Work Order ID 149129

Item ID: D4635-041 Accept ***N900040100*** Setup Start ***NS1***
Revision ID: Stop ***NS2***
Item Name: Fwd Ceiling Panel Assembly, LH
Start Date: 7/6/2016 Start Qty: 1.00 ***1*** Cust Item ID:
Required Date: 7/19/2016 Req'd Qty: 1.00 ***1*** Customer:
Reference:

D4635-041 LH, FWD CEILING PANEL ASSY

From: David Shepherd
Sent: May-11-15 12:58 PM
To: Nigel Forbes; Bill Beckett
Cc: Roberto Fuentes; Linda Lacelle; Mario Poulin; Daryl Leger; Harvey Siemens
Subject: RE: 139 Ceilings Deviation

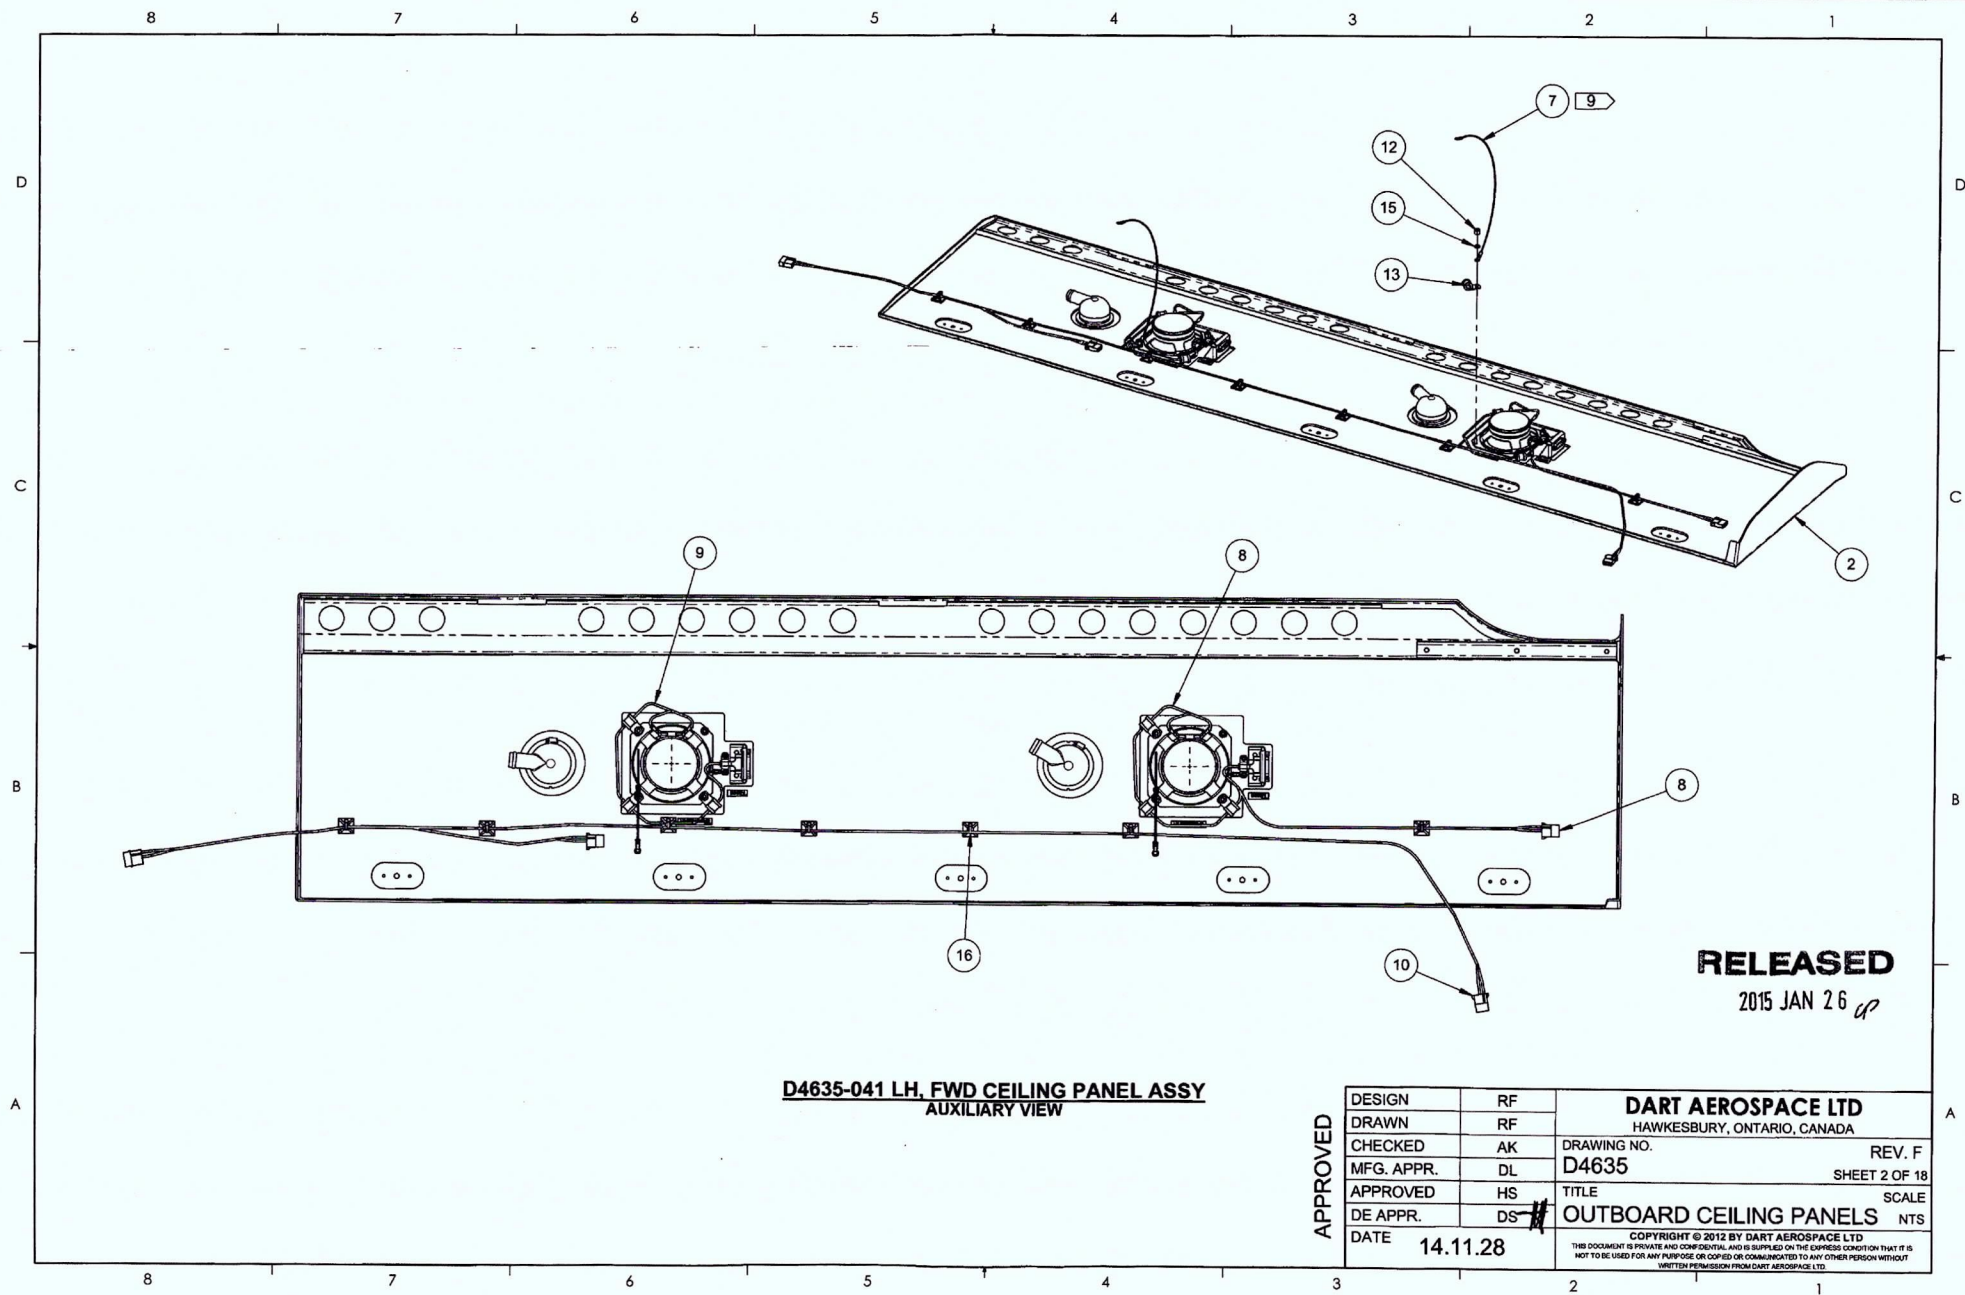
F	D4652-5 WAS D4652-1 (ZN D4-1, D4-3, D4-5, D4-7)	RF	14.11.28
E	REVISE BOM (ZN D4-1, D4-3, D4-5, D4-7); ADDED NOTE 11) (ZN A8-9, A8-10, A8-11 & A8-12); REVERSE VIEW - 142/-144 (ZN B6-10, B6-12); RANGE 1.5-1.8 WAS 1.8 (ZN A7-17); DIMENSION HAS SHIFTED DUE MATERIAL THICKNESS	RF	14.01.09
D	CORRECTING VIEW FOR ITEM 8 (ZN B2-2); ADDED D5022-1 (ZN D4-9, C3-9, D4-10, C2-10), D5022-3 (ZN D4-11, C8-11), D5022-5 (ZN D4-12, B6-12); DIMENSION SHIFTED DUE ADDING D5022-1/-3/-5; REVERSE NOTE 10) (ZN A8-9, A8-10, A8-11, A8-12); NOTE 1) (ZN A8-13, A8-14, A8-14, A8-15, A8-16)	RF	13.12.09
C	REVISE NOTE 8) (ZN A8-9, A8-10, A8-11 & A8-12); 32 WAS 34 (ZN C5-15, B5-16); CORRECT TYPO #1 WAS #3 (ZN D4-3); CHANGE TOLERANCE (ZN C3-13, B2-14, B5-17, B7-17, D2-17, D4-17, A3-18)	RF	13.06.18
B	ADDED D4635-141/-142/-143/-144 (ZN B4-9, B4-10, B4-11, B4-12); REVISE D4635-041/-042/-043/-044 PART LIST & GENERAL NOTES; ADDED D4732-41 (ZN B5-8); CHANGE TO D4743-1 SPEAKER GRILL AND MS24693-BB51 SCREWS (SHT 1, 3, 5, 7); ADD VIEWS R-R (ZN A7-17) AND S-S (ZN A5-17); UPDATE DETAIL 'D' (ZN C7-18)	RF	12.11.30
